21 July 2023

**EnergyAustralia**

**Meeting system strength requirements in Queensland from December 2025 – RIT-T Project Specification Consultation Report – 29 March 2023**

**Figure 17** Gin Gin node fault level duration curve against the minimum fault level requirement

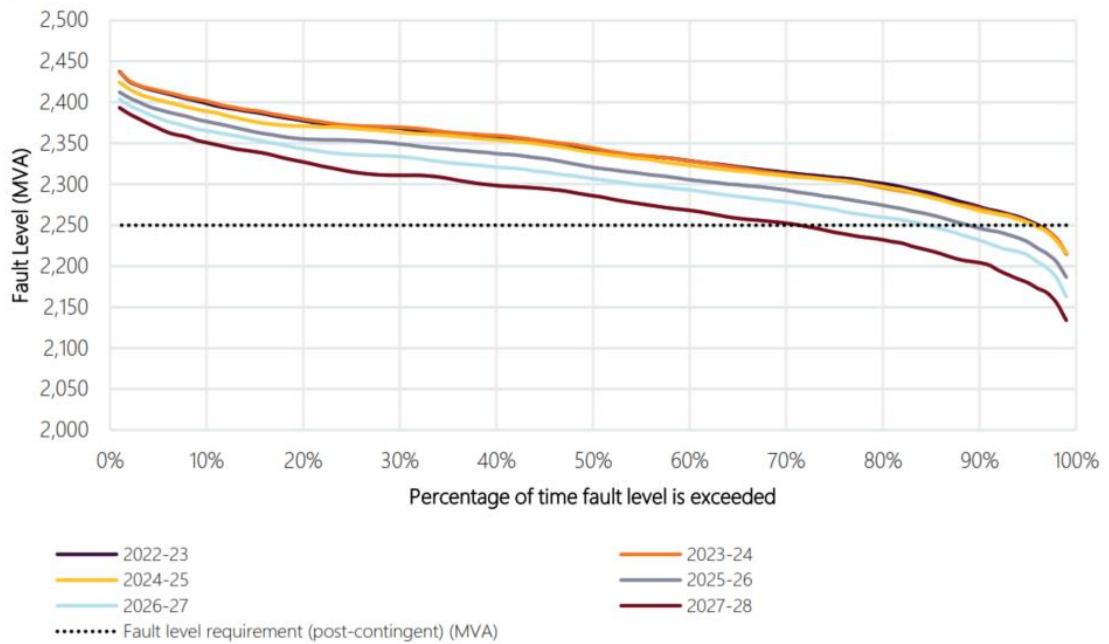
As illustrated above, AEMO’s 2022 System Strength assessment states that there is only a fault level shortfall at the Gin Gin node out to 2027-28, which has been previously identified. It is not clear how this affects Powerlink’s assessment of need nor what action Powerlink may already be taking to address this. The factors listed by Powerlink as affecting AEMO’s declared inertia shortfall<sup>4</sup> seem likely to also influence system strength needs, especially the transition of existing coal generators under the Queensland Energy and Jobs Plan.
